# Attachment A – Module 4 – Schematic Design Review Comments

**District:** City of Somerville **School:** Somerville High School

Owner's Project Manager: PMA Consultants, LLC Designer Firm: Symmes, Maini & McKee Associates

Review Date: January 4-12, 2017 Reviewed by: K.Brown, J. Jumpe

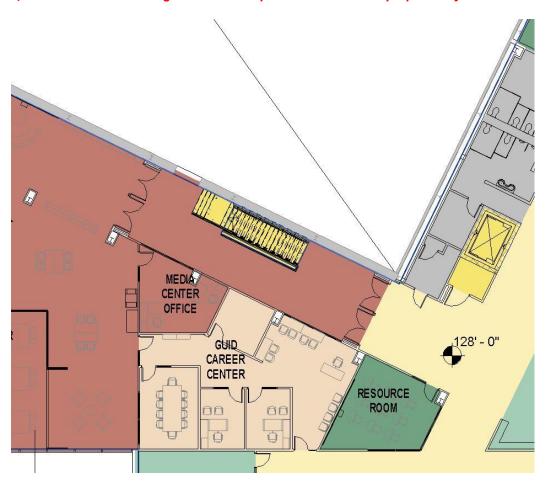
Total Building Gross Floor Area - The District is proposing a total of 377,192 gsf (including the 9,088 mechanical space) which exceeds the MSBA guidelines by 34,244gsf. The proposed area has increased by 3,819 gsf since the PSR submittal. The grossing factor with the mechanical space is 1.54, and 1.50 exclusive of the 9,088 gsf in mechanical space. The District is proposing to modify the northern elevation for the Mechanical Support Area (representing 7,084 gsf) located at the Parking Level. The design of that wall would change from a series of louvers surrounded by exterior wall construction to a series of openings with ornamental metal grillage infill for security purposes. By adjusting the design of this exterior wall, the Mechanical Support Area at this level will effectively become an exterior space, and materially no different than an exterior roof area or the exterior vehicular ramp that is currently located on the northern elevation of the Lower Level in the existing building. The air handling units in this space would be provided with weatherproof enclosures and mounted on concrete pads, the ductwork feeding them would need to be both insulated and weatherproofed, a gravel surface would replace the continuous concrete slab on grade, and the drainage design for that area of the building would be revised accordingly. Omitting the 7,084 gsf for the Mechanical Support Area from the building total area would reduce it to 370,108 gsf, resulting in a revised overall grossing factor of 1.51.

To: Karl Brown Date: 1/25/17 Page No: 5

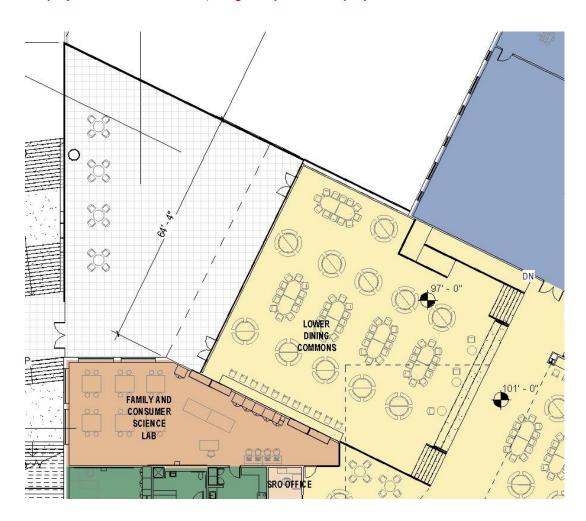
**Dining & Food Service** – The District is proposing a total of 12,760 nsf which exceeds the MSBA guidelines by 612 nsf. The proposed area in this category has increased by 825 nsf since the PSR submittal. The MSBA takes no issue with the proposed area in this category, which is located in the new portion of the building. However, 612 nsf of area in this category will be considered ineligible for funding by MSBA.

The District proposes reducing the overall size of the project by 612 gsf by moving the western-most exterior wall of the Dining Commons east approximately 10 feet. Additionally, the line of demarcation between the Dining Commons and the surrounding hallway circulation would be adjusted so that the Dining Commons itself would be reduced to a size of 7,170 nsf, allowing the overall Dining & Food Service space category to become the MSBA recommended size of 12,148 nsf. The total gross building area for the project would become 376,580 gsf as part of this proposal.
